ACCESSION NBR: 8002040417 DOC. DATE: 80/01/30 NOTARIZED: NO DOCKET #
 FACIL: 50-410 Nine Mile Point Nuclear Station, Unit 2, Niagara Moho 05000410
 ADTH. NAME AUTHOR AFFILIATION
 RHODE, G.K. Niagara Mohawk Power Corp.
 RECIPIENT NAME RECIPIENT AFFILIATION
 RUBENSTEIN, L.S. Light Water Reactors Branch 4

SUBJECT: Forwards geological info for util as per 791025 ltr to NRC.
 Response to Request 361.5 will be provided by 800229.
 Response to Request 361.24 will be submitted w/responses to
 remaining four requests by 800601.

Re: Nine Mile Point Unit 2
Docket No. 50-410

FIG 361.4-1

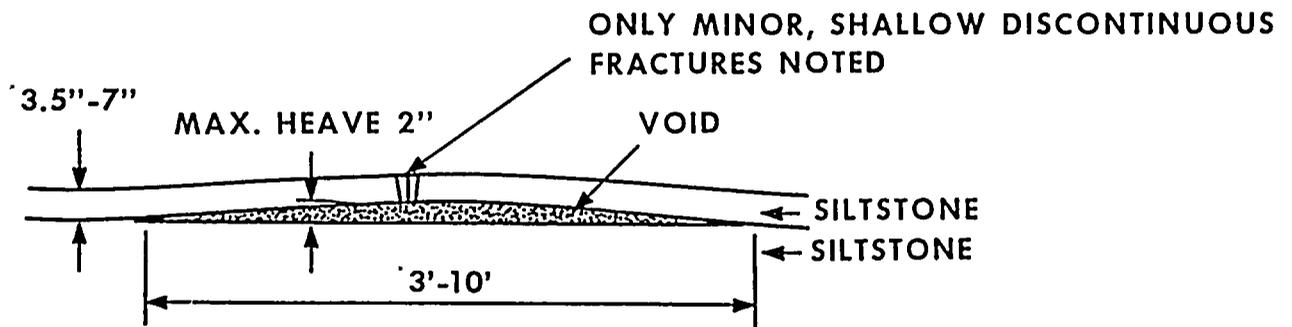
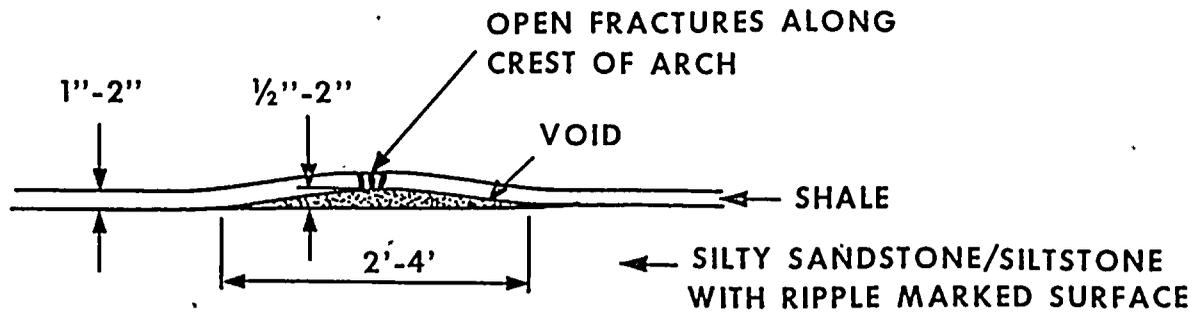
Was there evidence of heave in the bedrock floor or differential movements along faults, joints or bedding planes during the excavation of the Unit 2 site, or at any time following the completion of those excavations? Describe the amount, direction and rate of movements of any such adjustments.

All excavated rock surfaces were routinely checked by geologists during the progress of the excavation. Several lines of evidence were observed that can be attributed to heave of the bedrock floor, differential movements along bedding planes, and separation along joints. These observations include small buckle folds in the floors of excavations, a displaced heave monument borehole, offset boreholes and inclinometer readings that indicate bedding plane slippage. Descriptions of the various observations are provided.

A. Buckle Folds:

A buckle fold in the Control Building was noticed on August 12, 1976, following removal of muck which had been left in place since February 3, 1976 when a 25-foot rock column was blasted. Therefore, a period of six months, including the last part of winter, was available for heave development. This buckle appeared in a 1 to 2 inch thick shale layer overlying silty sandstone-siltstone, was 35 to 40 feet long and 2 to 4 feet wide with a N35°W trend, a 2-inch maximum amplitude and cracks on the crest (Figure 361.4-1). The floor of the Control Building excavation is 38 feet below the original bedrock surface.

The floor in the Circulating Water Encasement had not shown any anomalous features for four months from May 19, 1976, when the rock was removed immediately after blasting to September 20, 1976, when the floor was cleaned and geologically inspected. The buckle was discovered six months later at the beginning of April 1977, when the floor was again inspected in preparation for pouring mat concrete. The buckle was approximately 14 feet long and the crest-line was oriented N08°W to N30°E. The wave length of the buckle ranged from approximately 3 feet to 9.5 to 10 feet and the amplitude 1.75 inches. Dilation was apparent between a folded siltstone bed and an underlying siltstone bed creating a 1.75 inch void. The thickness of the arched layer ranged from a minimum of 3.5 inches to a maximum of 7 inches (Figure 361.4-1). The floor of the Circulating Water Encasement excavation is 35 feet below the original bedrock surface. Each of these buckle folds were confined to the floors of the excavations and did not affect the bedrock walls.

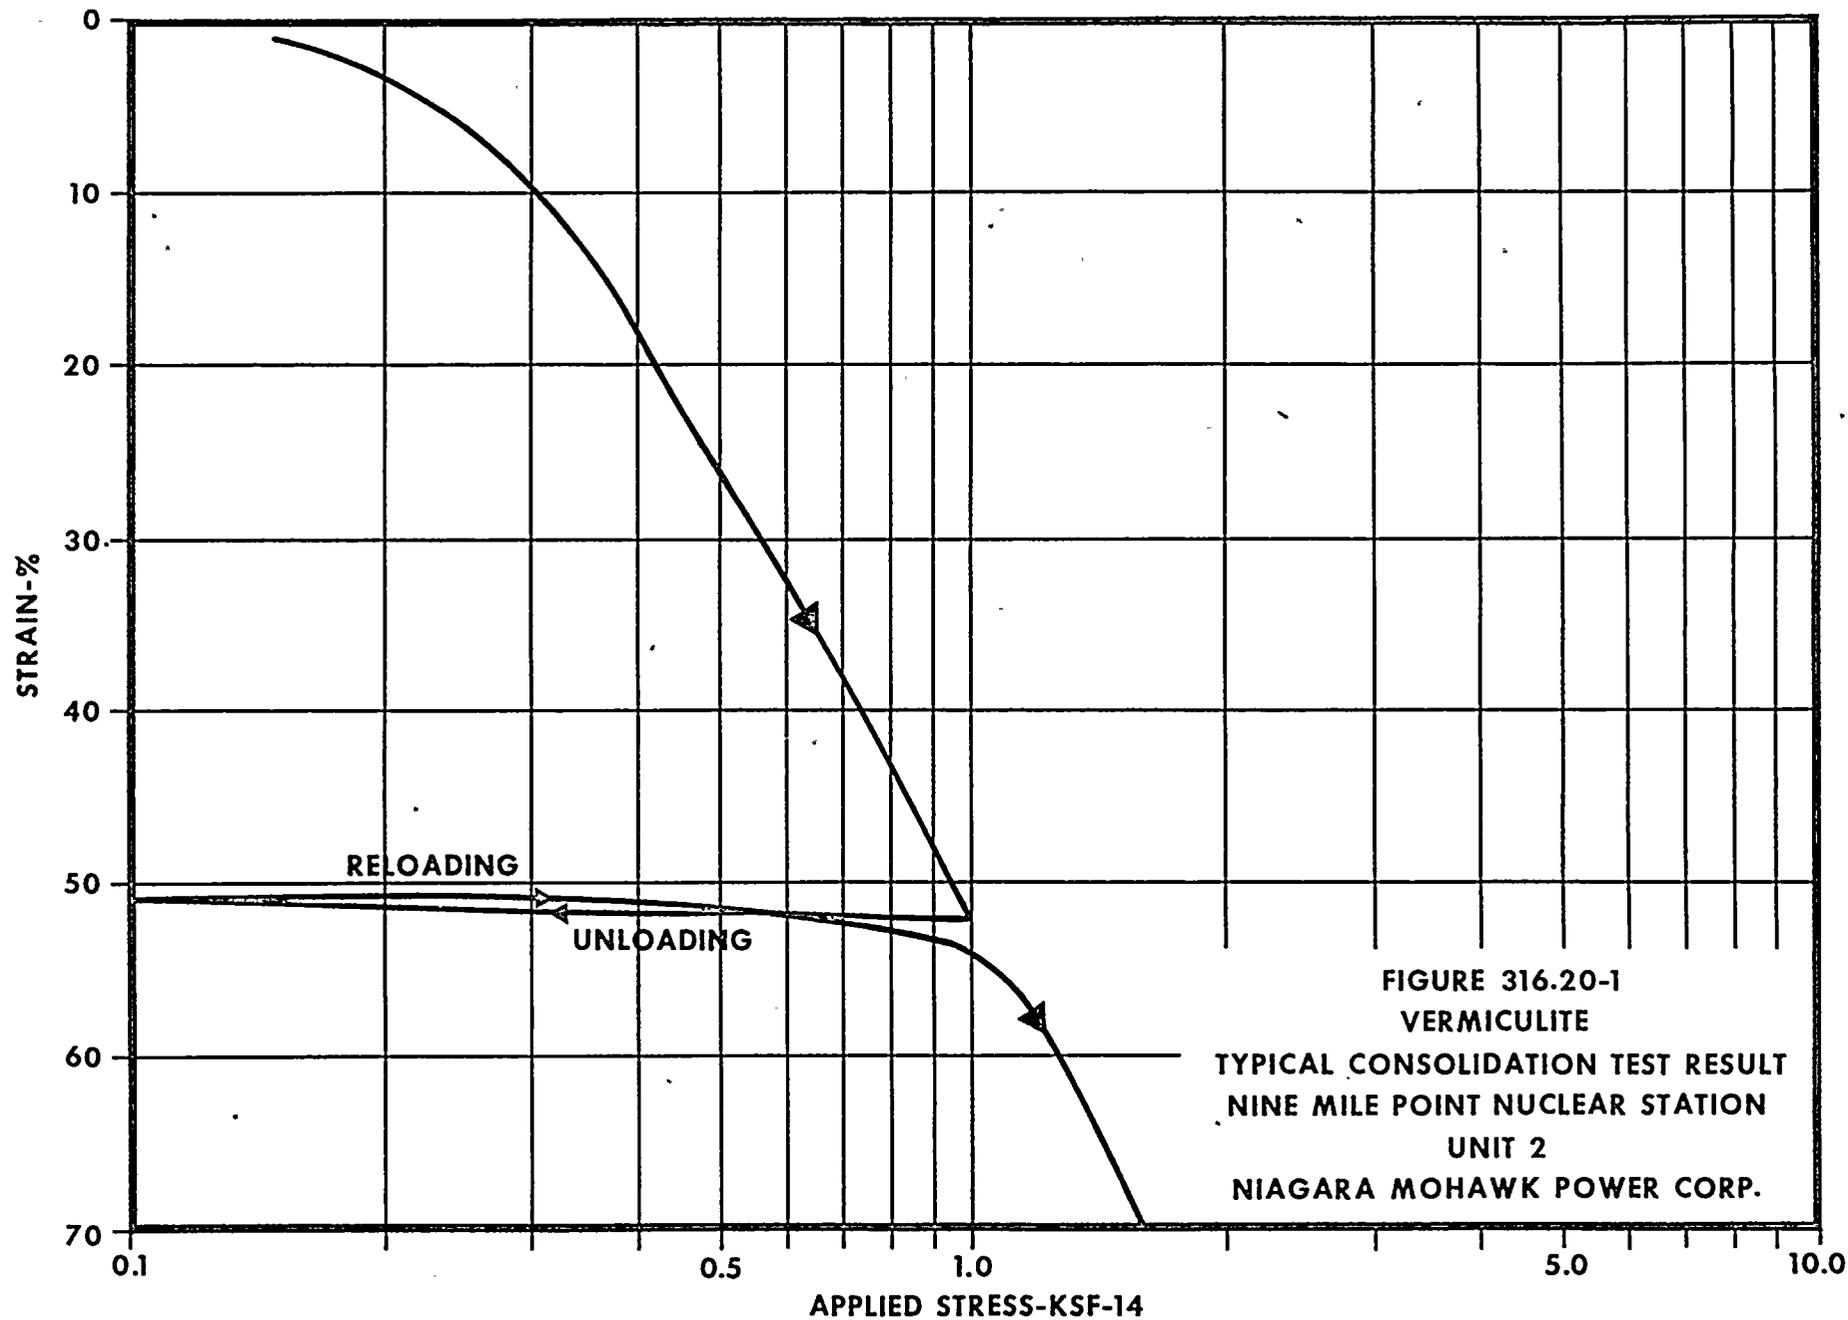
As of the time of the April 24 meeting, it had not been decided what type of deformable material would be used to backfill the 6 inch slot between the structures walls and bedrock. We request that you keep us informed as to the decisions made and the reasons for those decisions.

It has been decided to use vermiculite to backfill most of the slots between the structure walls and bedrock. Placement of vermiculite or Nufoam filler materials in the slabs will maintain the slot spaces free of accumulations of rock chips or other relatively incompressible foreign materials. The vermiculite is to be loosely placed. This material will minimize load transfers to building walls by absorbing the horizontal rock displacements predicted. The vermiculite materials used are Zonolite Brand, Expanded Vermiculite, Grade No. 1 or Grade No. 2, as manufactured by W.R. Grace and Company.

Vermiculite backfill was selected because it is widely used as a construction material. It is relatively easy to install and highly compressible.

A series of one-dimensional incremental consolidation tests using soil testing oedometer equipment performed on the vermiculite. The backfill pressures due to horizontal rock movements were based on results of this type of testing. A typical compression curve is presented in Figure 316.20-1. The discontinuity shown in the curve is a result of unloading and reloading during the test.

FIGURE 361.21-1
VERMICULITE CONCRETE COMPOSITE CURVE
CONFINED COMPRESSION TESTS
NINE MILE POINT STATION - UNIT 2
NIAGARA MOHAWK POWER CORPORATION

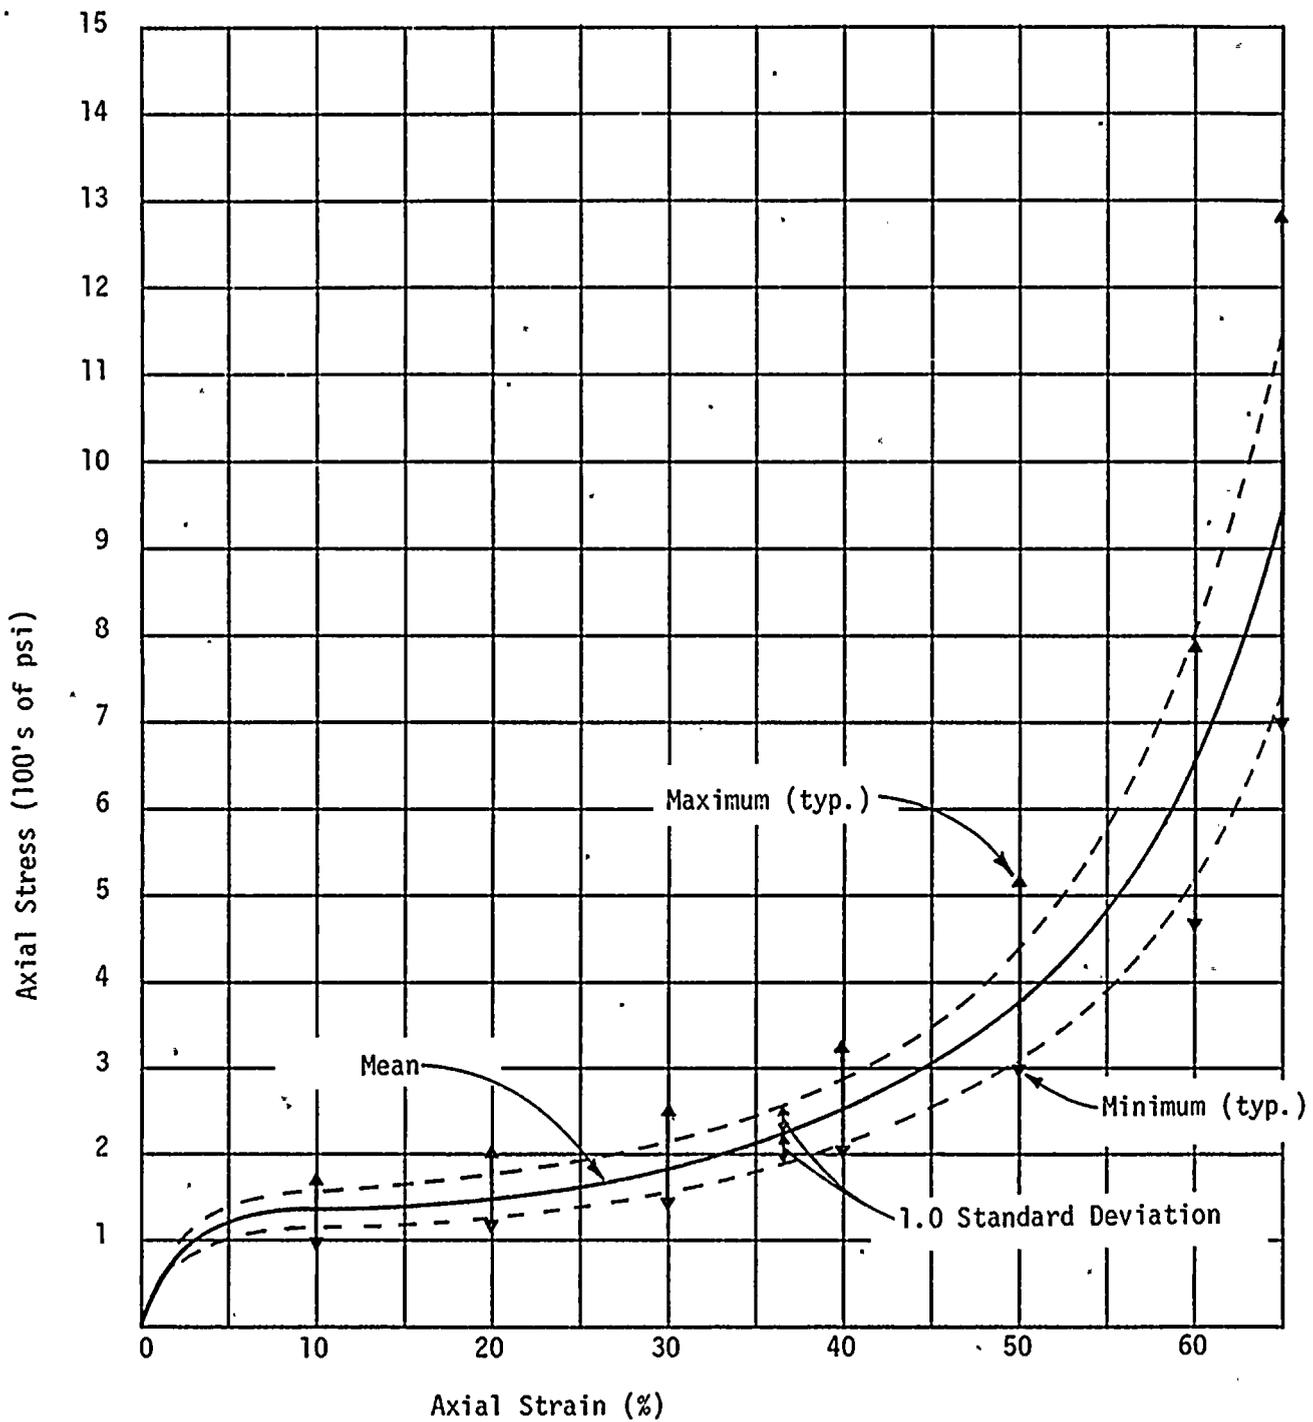
As stated earlier vermiculite concrete has been used between the foundation slabs and rock. Describe the mix used and provide the laboratory tests on which you base the design of the slot backfill. Include the data for both the foundation and wall slot backfill.

One-dimensional compression tests were used in predicting lateral loads transferred to structures as a result of rock movements. A series of one-dimensional confined compression tests performed on 13 samples taken from different placement sections at the site is presented in Figure 361.21-1 to illustrate the compressibility properties of this material.

NIAGARA MOHAWK P.C.	
NINE MILE PT. NUCLEAR STA #1 REACTOR BLDG. WALL CRACK	
DESIGNER	DATE 1-30-52 SCALE 1/8"=1'-0"
FIGURE #1

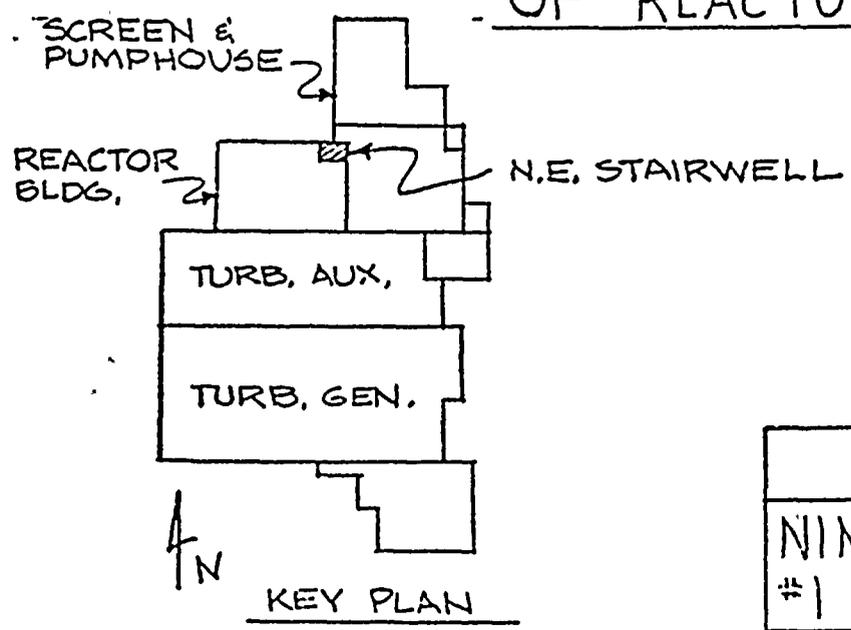
Q361.22 During the meeting on April 24, 1979, Niagara Mohawk indicated that a crack in the northeast corner of the secondary containment was suspected to have been caused by high bedrock stresses. It was further stated that monitoring of the wall was currently underway. Describe the crack and discuss the reasons why you attribute the cause of the crack to rock squeeze. Describe the monitoring program and provide the results obtained to date. It was learned at the meeting that a space at least three feet wide had been constructed between the rock and the structure's wall. Is this indicative of rock movement on the order of several feet into the slot? Discuss.

RESPONSE The location and dimensions of the crack were originally documented in March 1977 (see Figures 1 and 2). It is located in the exterior north wall of the Nine Mile Point Unit 1 Reactor Building approximately 10.5 feet to the west of the east wall. At its maximum, it is one-eighth of an inch wide at a point approximately eighteen inches below the one foot ledge at Elevation 237 feet. At a point six feet below the ledge, it is approximately 1/32 inches wide. The crack extends down from the ledge at Elevation 237 feet approximately eight feet and extends above the ledge about the same distance. The upper and lower ends of the crack disappear in a random hairline pattern.

The cause of the crack has not been determined. As shown in Figures 1 and 2 the west wall of the Screenwell Building is in contact with (but not attached to) the north wall of the Reactor Building. With this structural configuration, there are several ways that the west wall of the Screenwell Building could contribute to the cause of the crack. Cracking of concrete can be attributed to relatively low temperature changes causing elongation in the intersecting Screenwell Building wall during original construction. From the attached figures, it can also be seen that small movements of the rocks supporting the Screenwell Building wall could produce sufficient load to cause the cracking in the Reactor Building wall.

When the crack was originally found in March 1977, a measurement was taken perpendicular to the wall to a reference point in the stairwell. This measurement was checked in May 1979 and negligible change was recorded. The present monitoring system consists of two parallel bars anchored side-by-side, one to each side of the crack line at elevations 236 feet and 232 feet (see Figure 3). This system will detect horizontal movement of the crack (widening) by separation of the two parallel bars anchored side-by-side. Vertical elongation of the crack is being monitored by means of measurement with a tape. Measurements are taken semiannually.

FIGURE 361.23-1
 TYPICAL PIEZOMETER
 INSTALLATION
 NINE MILE POINT NUCLEAR STATION
 UNIT 2
 NIAGARA MOHAWK POWER CORPORATION

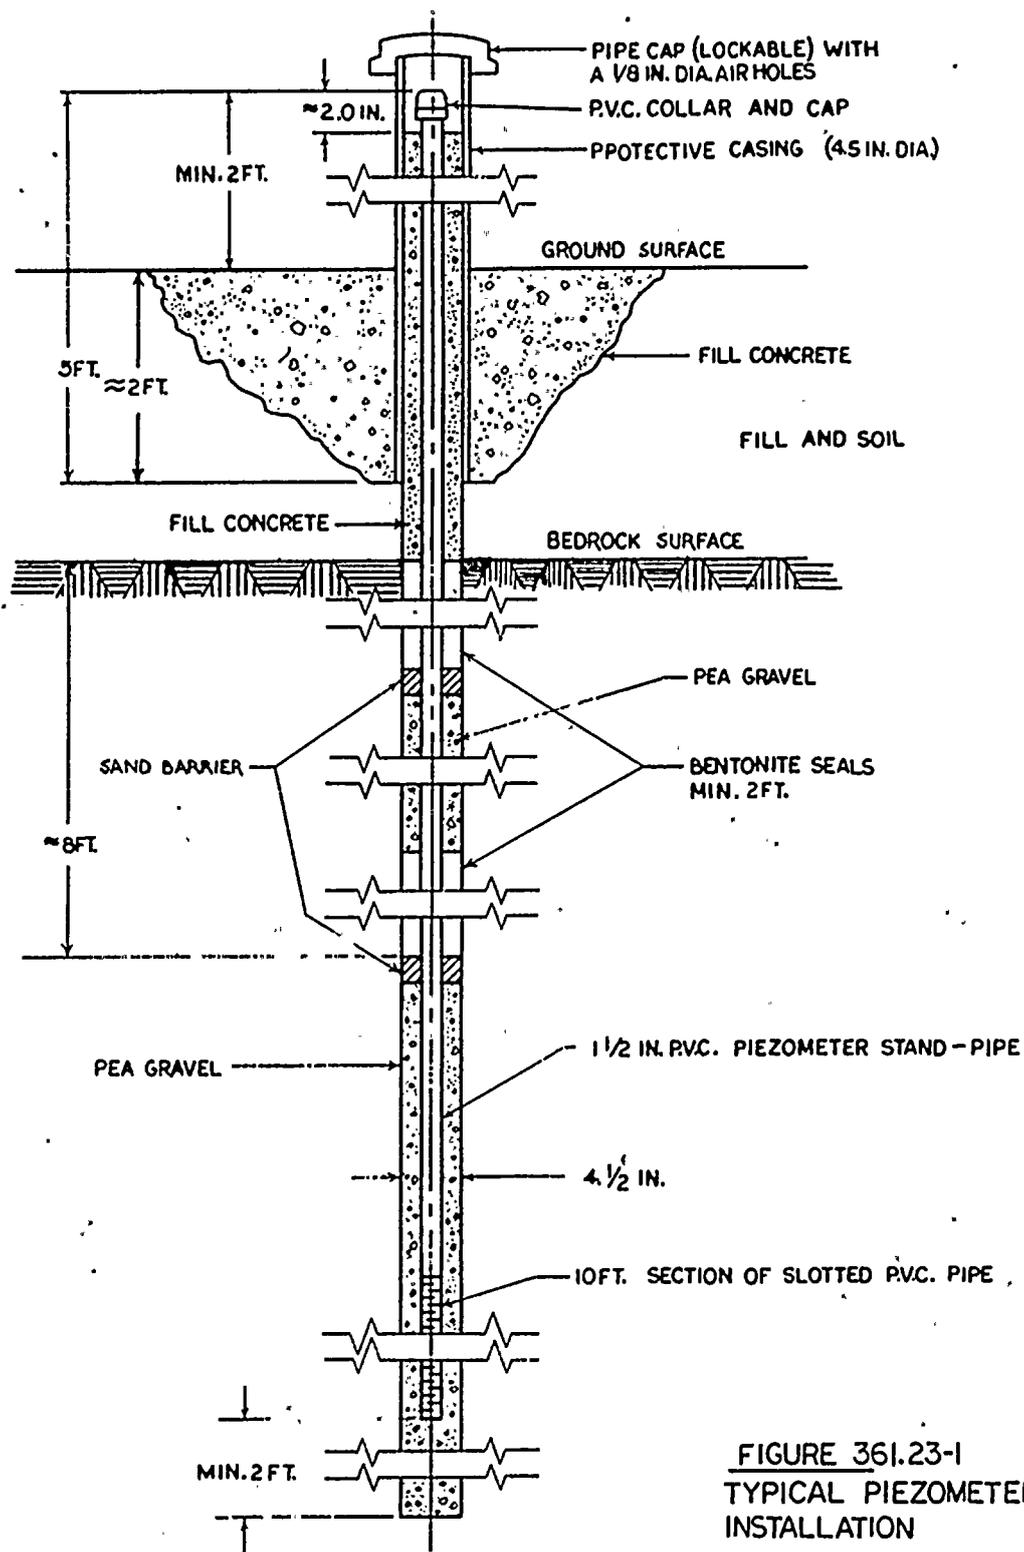
Describe the standpipe installations for measuring groundwater pressure.

In addition, four standpipe type piezometers were installed to measure the groundwater levels in the vicinity of the reactor excavation. The piezometers were installed during April 1979. Water level measurements have been taken at regular intervals (mostly weekly or bi-weekly) since installation. A typical piezometer installation is shown in Figure 361.23-1.
